**EQUIPMENT INSTALLATION ONLY. Veterans Memorial Ice Rink,
Mechanical Improvements**

ADDENDUM NO. 1

January 8th, 2018

DRAWING TITLE **HEAT RECLAIM DIAGRAM**

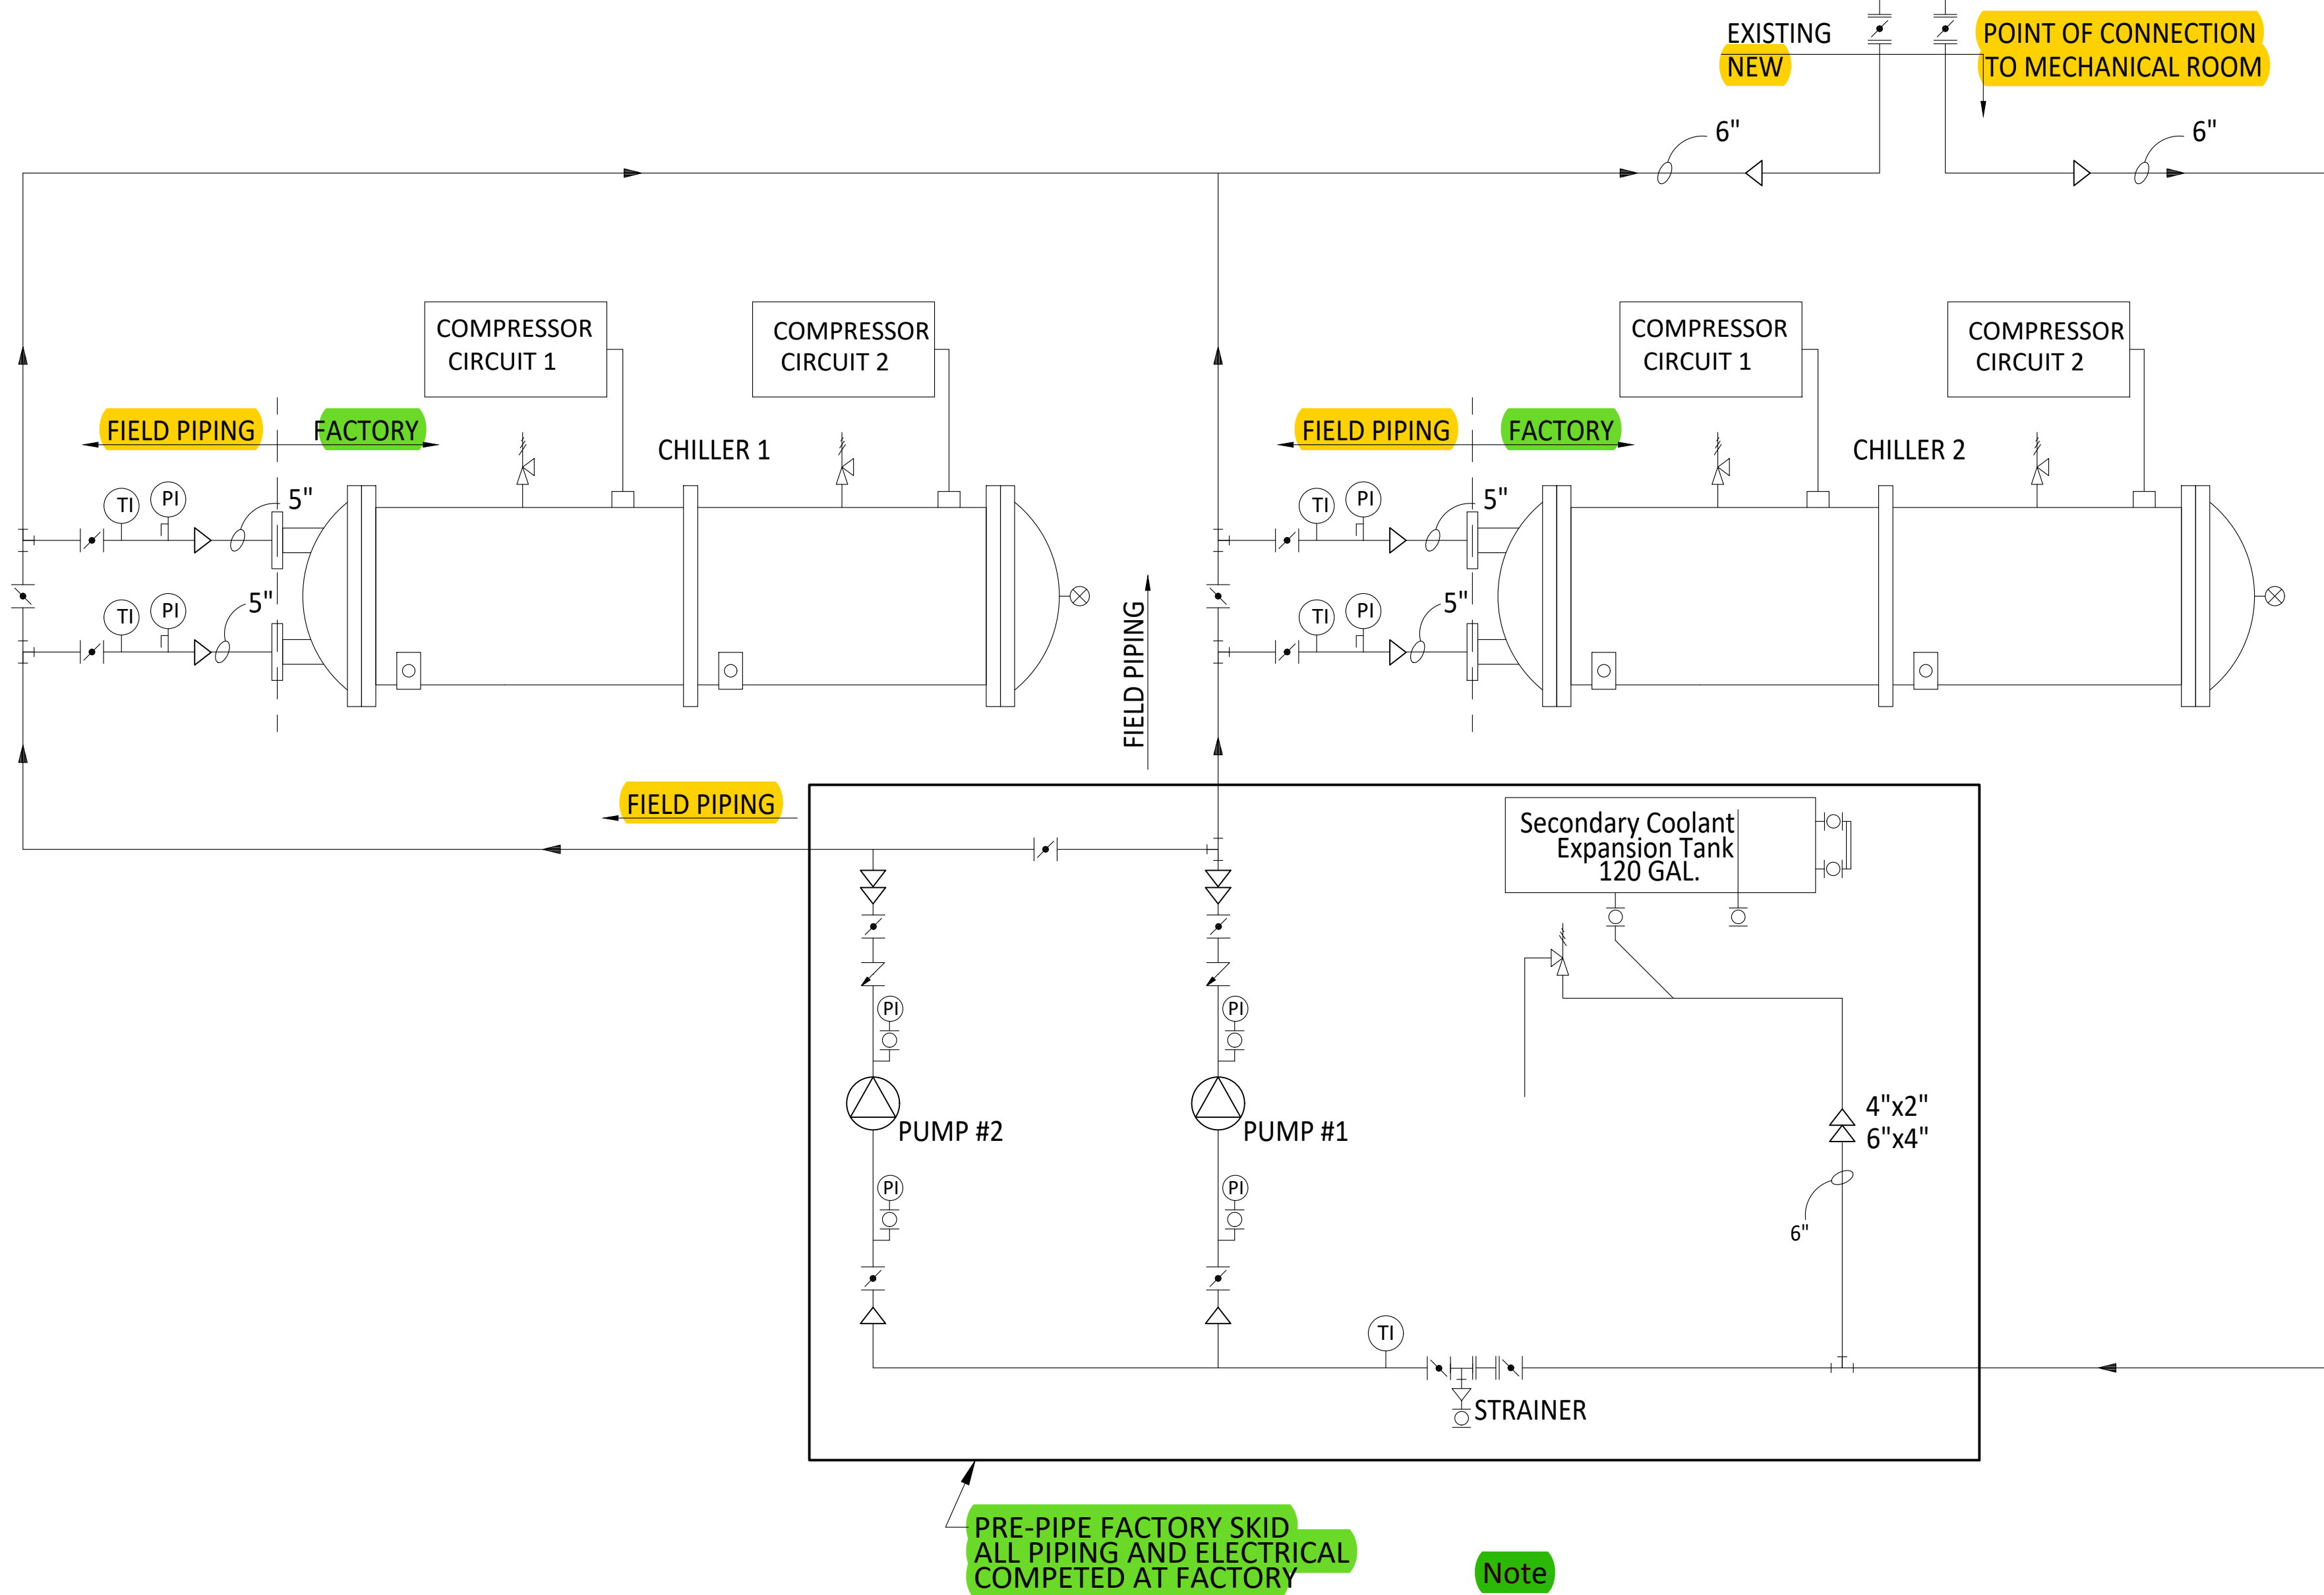
PIPING TO BE RECONFIGURED BY CONTRACTOR SO THAT THE TANKS FACE PIPED IN SERIES PERMITTING TANK 1 TO SERVE AS STORAGE TANK.

Revision date 01/02/2018
Highlights to depict demarcation between factory and field piping

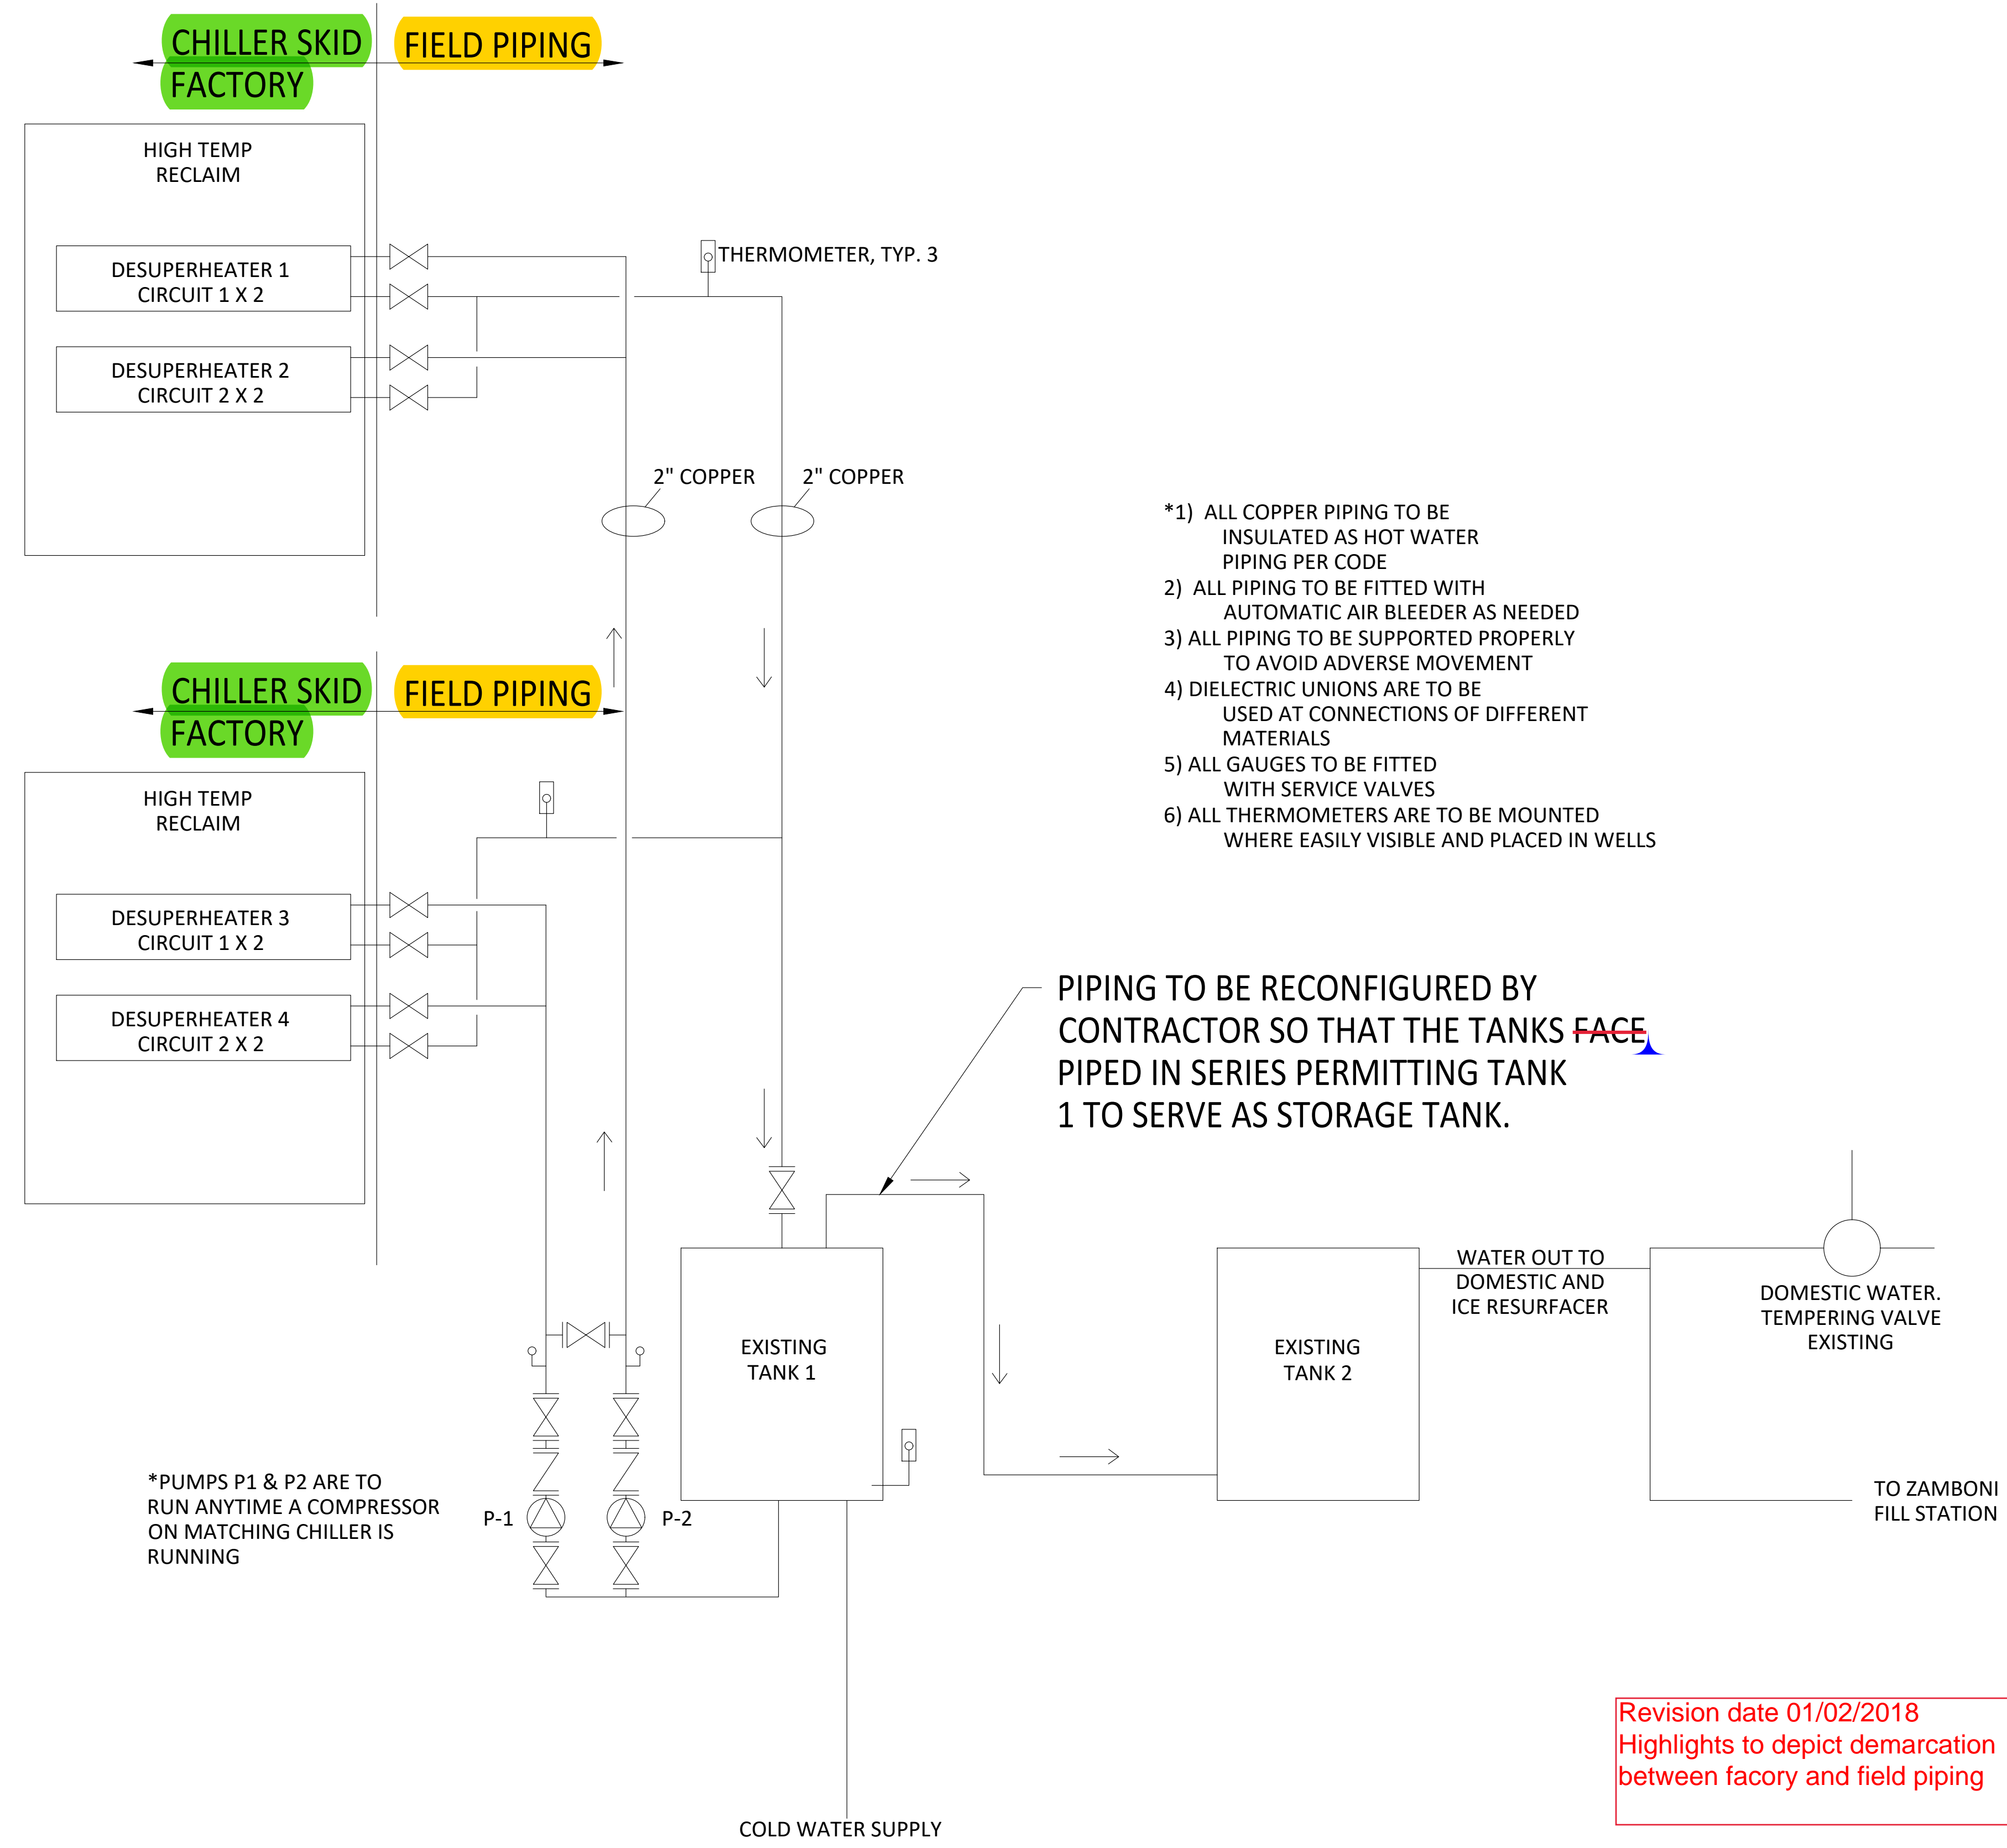
Revision date 01-02-2018.
Highlighted for demarcation
between factory and field piping.
